YEAR 4 (2019) MONITORING REPORT
AYCOCK SPRINGS
STREAM AND WETLAND MITIGATION SITE

ALAMANCE COUNTY, NORTH CAROLINA
DMS PROJECT No. 96312
FULL DELIVERY CONTRACT No. 5791
NCDWR PROJECT No. 20140335
USACE ACTION ID No. SAW-2014-01711

Subject: Draft Monitoring Year 4 Annual Monitoring Report
Aycock Springs Stream and Wetland Mitigation Site (DMS #96312)
Cape Fear River Basin 03030002, Alamance County
Contract No. 005791

Comments Received & Responses

FIGURE 2

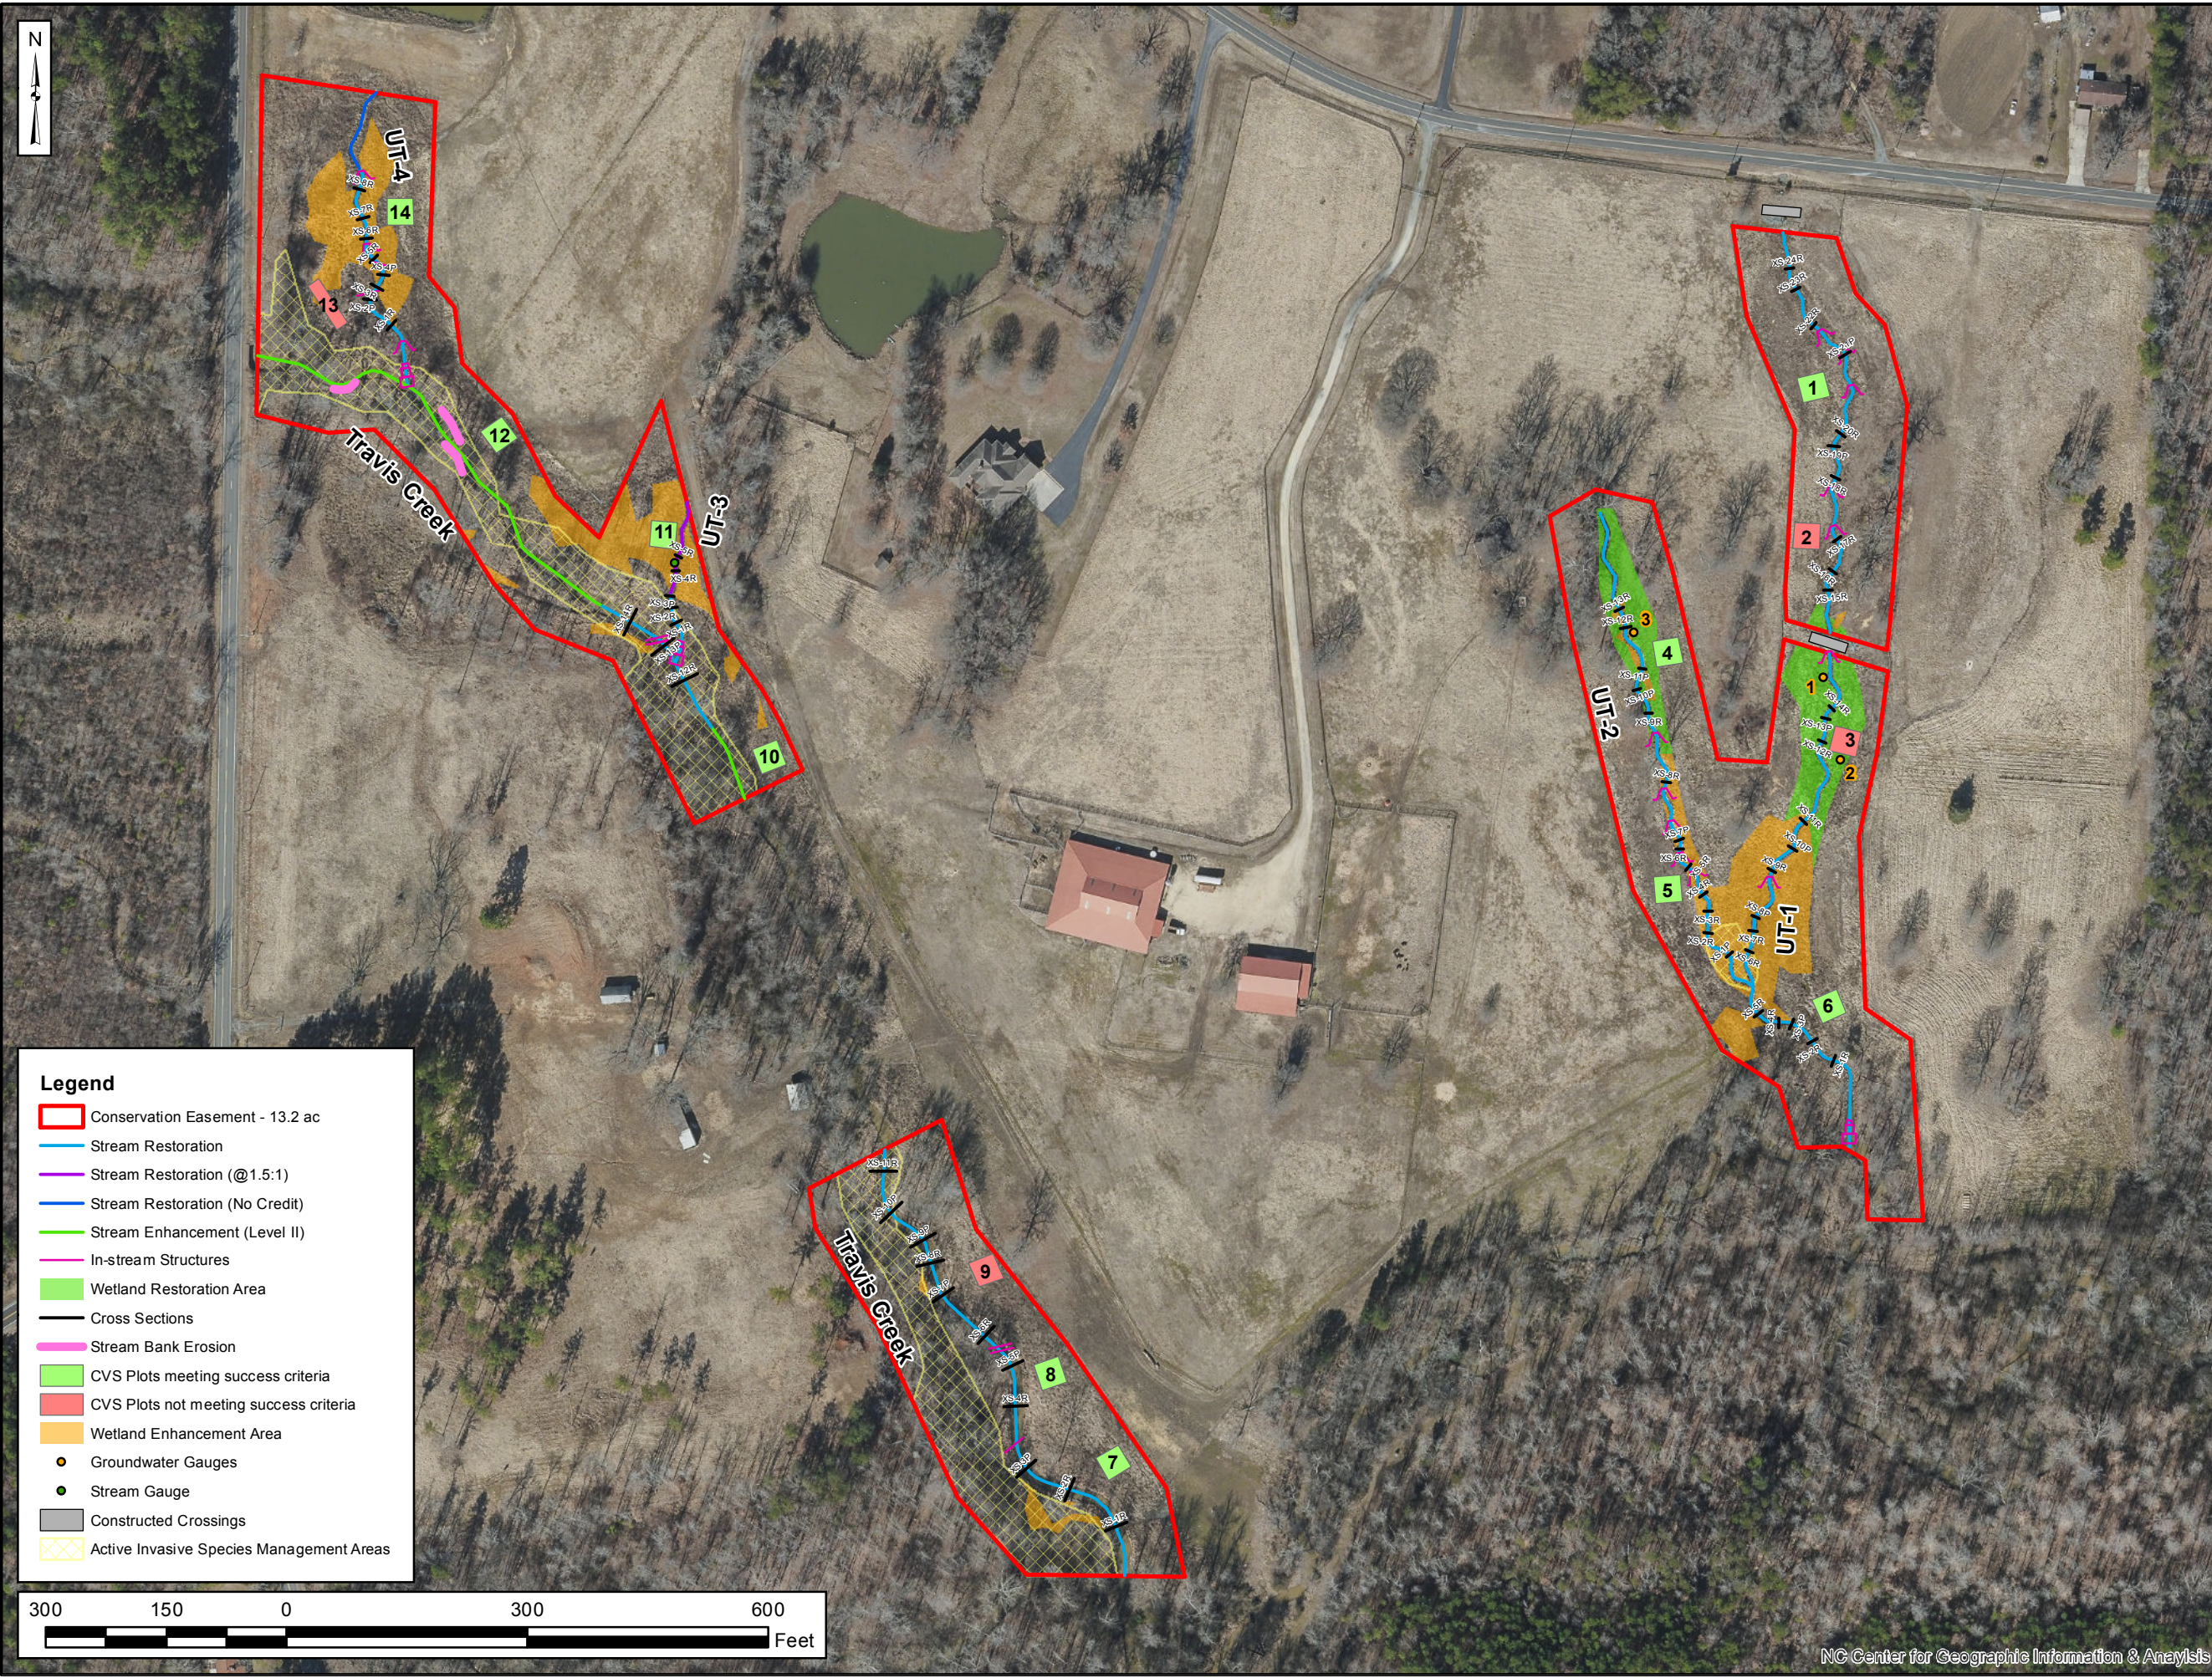
- a. Figure 2 – Please update the CCPV to differentiate between Restoration, Enhancement II, etc. Also, the surface water gauge for UT3 is not shown on the map.
The stream layer was updated to differentiate between mitigation types. The surface gauge is also now visible.

Aycock Springs Surface Gauge UT-3 Year 4 (2019 Data)

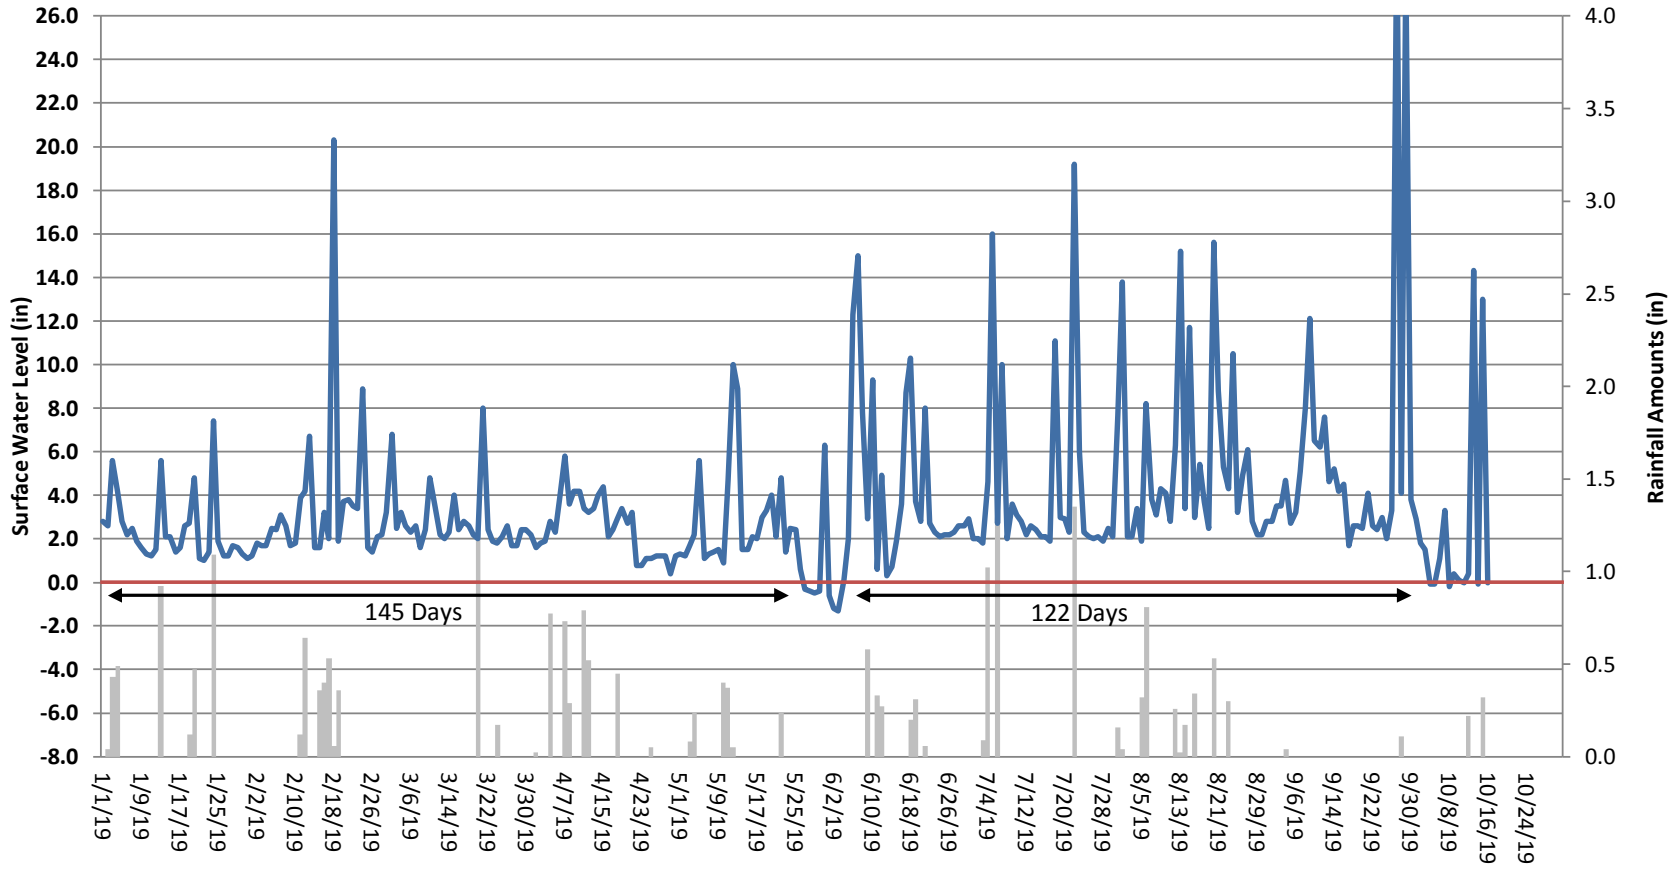
- a. Stream Gauge Graphs – Please correct the title on the graph (currently reads "Year 1").
The graph title has been corrected.
- b. Groundwater Gauge Graphs – Please add the graphs, they were not included in the Appendix.
The groundwater gauge graphs have been included.
